Council Ref: ROL/2024/116

Re: 41-53 Courtney Drive, Upper Coomera

Traffic Response to Residential ROL Council Further Issues

Figure 1: New Access Road / Baileys Mountain Road - Concept Intersection

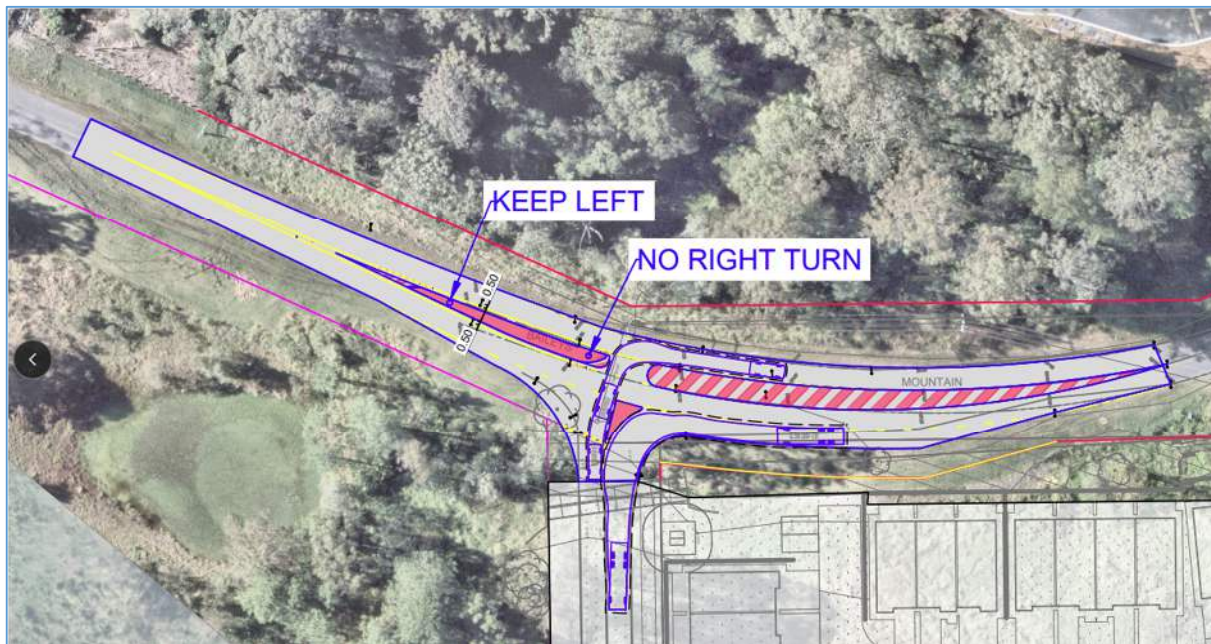
- a. Colliers' IR Response identifies that Safe Intersection Sight Distance (SISD) is not achieved at the following proposed new intersection locations:*
 - Courtney Drive access to proposed Stage 6; and
 - Proposed new public road intersection with Baileys Mountain Road.

- i. Submit revised 'Concept Plans' (i.e. functional intersection layout and development layout drawings) to demonstrate relocation of the proposed intersections in order to achieve compliant SISD, in accordance with Austroads requirements.*

- ii. A revised Traffic Engineering assessment shall be submitted to support the revised 'Concept Plan'; demonstrating that compliant SISD is achieved. Of note – commentary provided in Colliers' response does not justify non-compliant sight distances (data from multiple surveys identifies 85th percentile speeds of (at least) 70km/h on Baileys Mountain Road; signage does not overcome physical sight distance deficiencies; vegetation clearing is already considered in the assessment; and provision of turning treatments does not alter sight distance requirements). Compliant SISD must be demonstrated, particularly considering that the proposed development is in a greenfield site.*

Note: A functional layout drawing for the proposed new intersection in Baileys Mountain Road has not been submitted and is requested to be submitted in responding to this item.

- g. Submit revised 'functional layout' drawings to demonstrate any changes required to intersection designs / configurations, for the locations identified in part f. Functional layout drawings shall be fully dimensioned to demonstrate compliance with all relevant (Austroads and Council) standards.

Note – a functional layout drawing has not been submitted for the proposed new intersection with Baileys Mountain Road and shall be submitted in response to this item; non-compliances with respect to the proposed intersection configuration for the Courtney Drive 'Stage 6' access have been identified in part b, herein.

- i. Submit updated swept paths (using the 'design service vehicle') based on any amendments made to intersection designs / configurations.

A revised Concept Plan has been provided to Council as part of a traffic and transport response in relation to the development application for 202 Baileys Mountain Road. This Concept Plan outlines a minor realignment of the westbound section of Baileys Mountain Road (by ~3m) which provides sufficient sight distances to the east (under a constrained site parameter – 1.5 seconds reaction time) under the 70 km/h design speed, without requiring vegetation clearing outside of the existing verge.

Compliant sight distances to the west (70 km/h design speed at 2.0 seconds reaction time) with a minor truncation (beyond the standard 3-chord requirement) on the south-eastern corner of the subject site. An extract of the concept plan of the proposed New Access / Baileys Mountain Road is provided in Figure 1 overleaf, which also identify key design vehicle swept paths.

As noted previously, a revised Concept Plan has been provided to Council as part of a traffic and transport response in relation to the development application for 202 Baileys Mountain Road. This Concept Plan outlines a minor realignment of the westbound section of Baileys Mountain Road (by ~3m) which provides sufficient sight distances to the east (under a constrained site parameter – 1.5 seconds reaction time / 70 km/h design speed) , without requiring vegetation clearing outside of the existing verge and west (70 km/h design speed at 2.0 seconds reaction time) with a minor truncation (beyond the standard 3-chord requirement) on the south-eastern corner of the subject site.

An extract of the concept plan of the proposed New Access / Baileys Mountain Road is provided in Figure 1 overleaf, which also identify key design vehicle swept paths.

As noted previously, a revised Concept Plan has been provided to Council as part of a traffic and transport response in relation to the development application for 202 Baileys Mountain Road. This Concept Plan outlines a minor realignment of the westbound section of Baileys Mountain Road (by ~3m) which provides sufficient sight distances. Indicative swept paths for car exit and WCV design service vehicle entry (left-turn) are provided in the Concept Plan excerpt provided as Figure 1.

Figure 2: Baileys Mountain Road / New Access - Turn Warrants Assessment

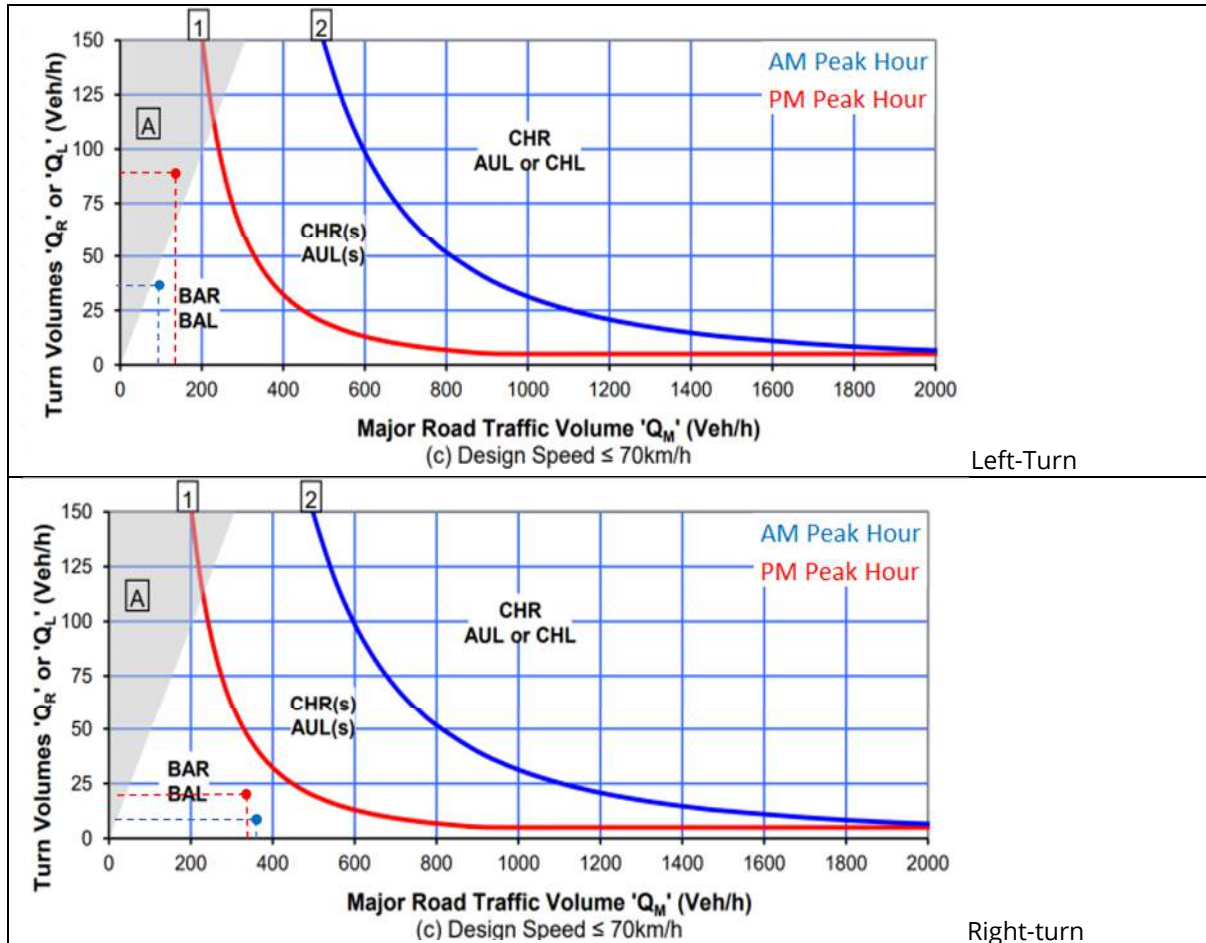
- f. Undertake revised turning warrants assessments, in addition to SIDRA Intersection assessments (where identified below), through to the 10-year design horizon, for the following intersections:*
 - i. Proposed new intersection in Baileys Mountain Road (SIDRA assessment also required).*
 - ii. Courtney Drive / Jenkins Court / Baileys Mountain Road intersection (revised SIDRA assessment also required).*
 - iii. Proposed new intersection in Courtney Drive ('Stage 6' access).*

- Growth rates consistent with Council's initial Information Request (i.e. for Baileys Mountain Road, use a compounding growth rate of 5.5% p.a., to 2037), rather than growth based on LGIP population estimates and growth, as adopted in Colliers' IR Response.*
- Revised traffic 'catchment', as identified in part c*
- With specific regard to the Courtney Drive 'Stage 6' access - revised through traffic volumes on Courtney Drive, incorporating 'development' traffic for both the subject development proposal and any development approvals / current development applications in the Courtney Drive Precinct).*
- Intersection layouts adopted for SIDRA assessments shall also be submitted as part of this request.*

An updated turn warrant assessment for the Baileys Mountain Road / New Access intersection is

provided below for both the left-turn and right-turn treatments as provided in Figure 2.

The updated turn warrant assessment identifies BAR / BAL treatments for consideration. The proposed BAR and AUL(s) treatments for the Baileys Mountain Road / New Access intersection meet and exceed the identified treatments and are considered appropriate.
